ORIGINATION FORM

Proposed Revisions to a Standard Plans Index
(Please provide all information – Incomplete forms will be returned)

Index Number: **654-001**
Sheet Number (s): 1
Index Title: Rectangular Rapid Flashing Beacon Assembly

LAST REVISION 11/01/18	DESCRIPTION:	 FY 2019-20 STANDARD PLANS	RECTANGULAR RAPID FLASHING BEACON ASSEMBLY	INDEX 654-001	SHEET 1 of 1
---------------------------	--------------	---	--	------------------	-----------------

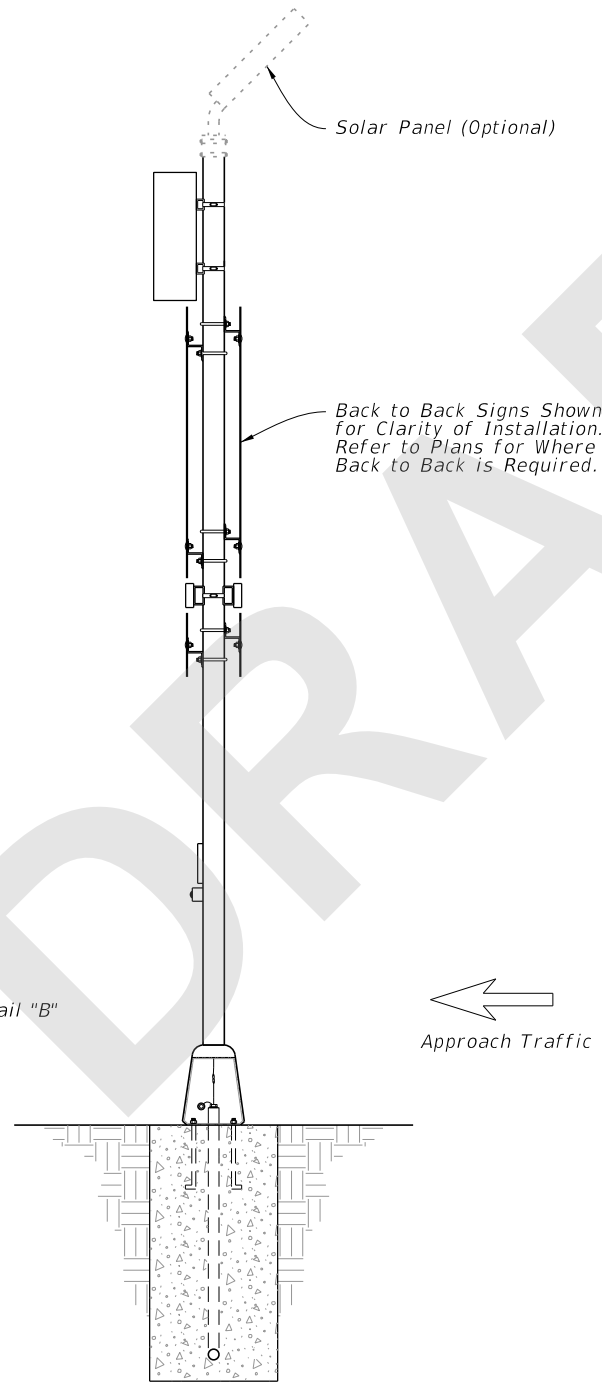
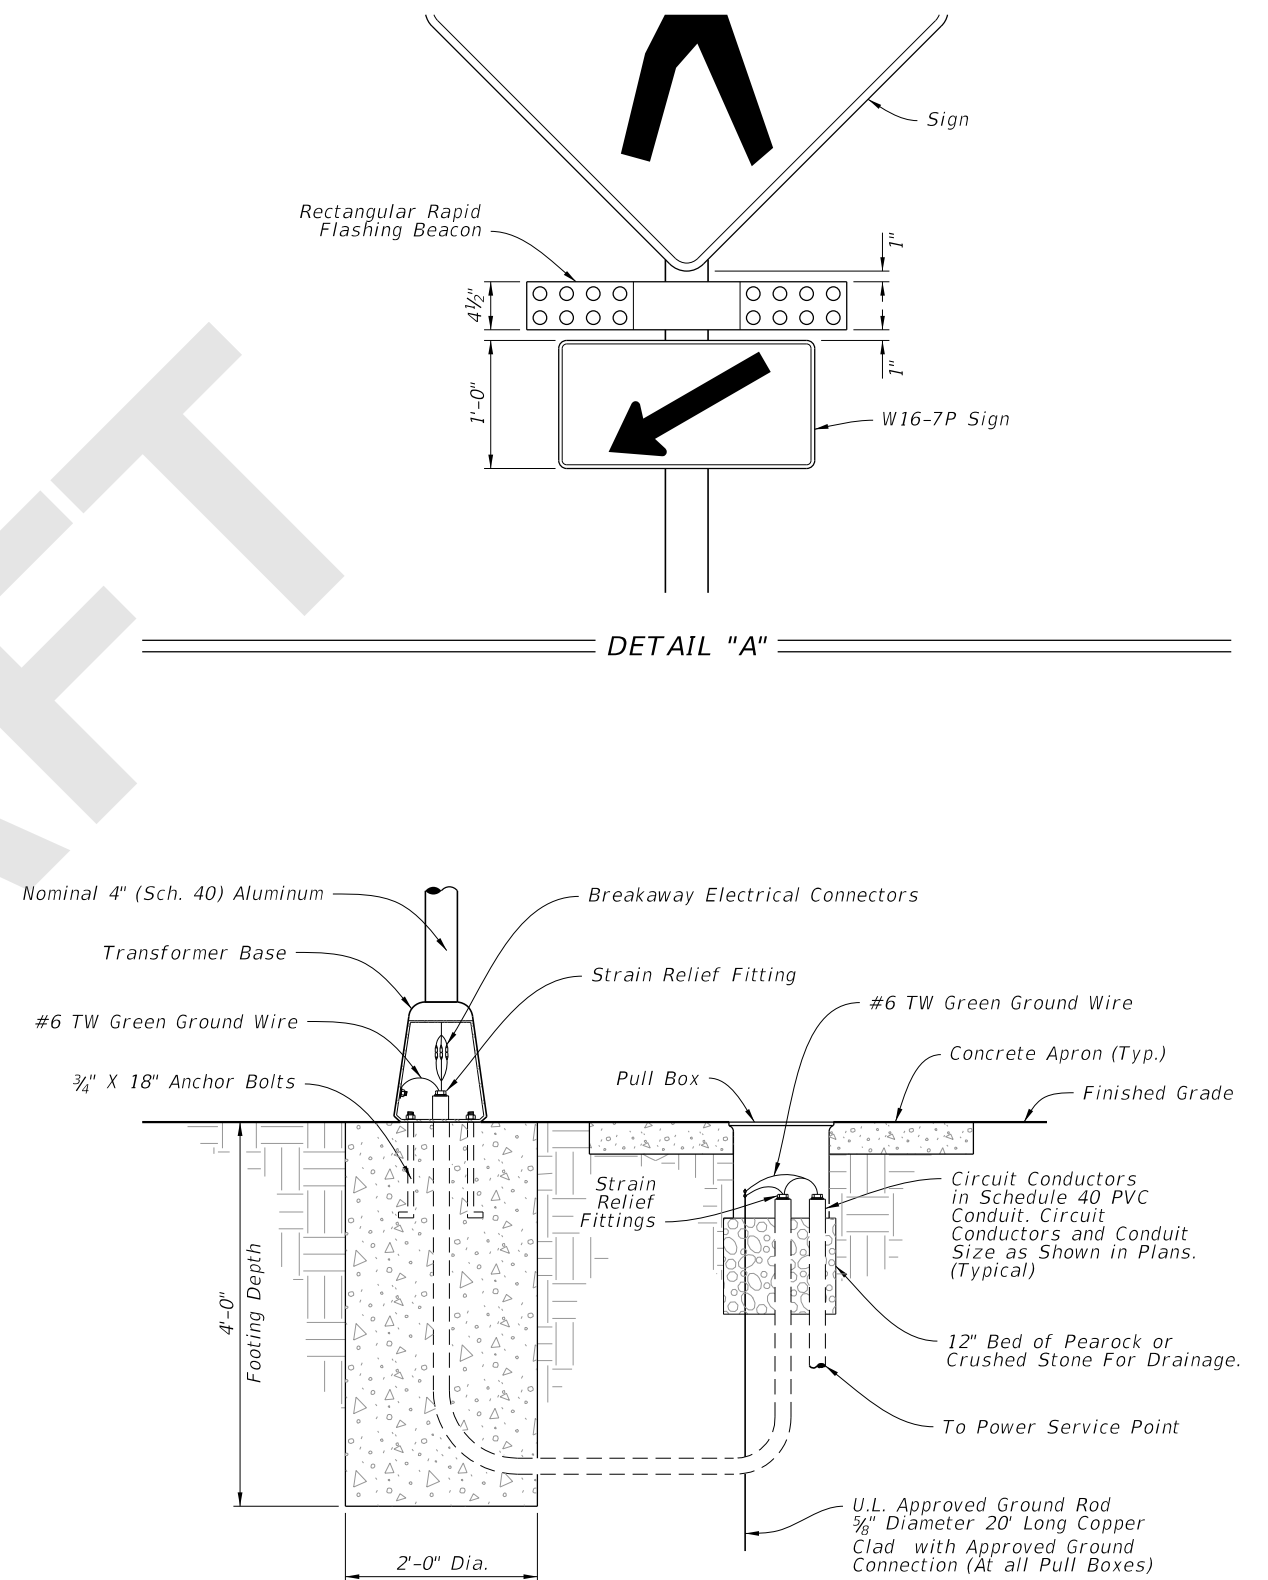
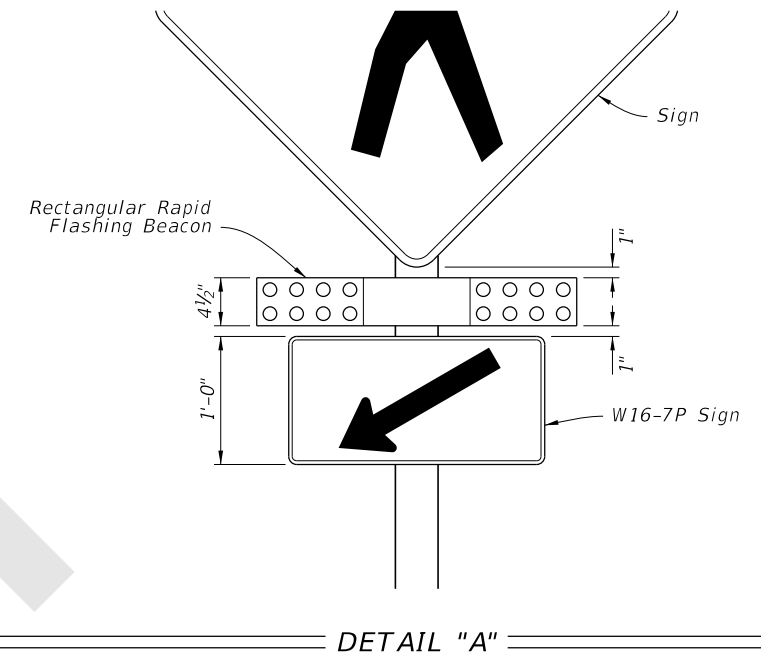
Sheet 1: Added new Index. Moved details from Index 700-120.

The rectangular rapid flashing beacon is a traffic control device housed in Specification 654. The details for the rectangular rapid flashing beacon were previously in Index 700-120, which is meant to be for regulatory signs that require additional conspicuity.
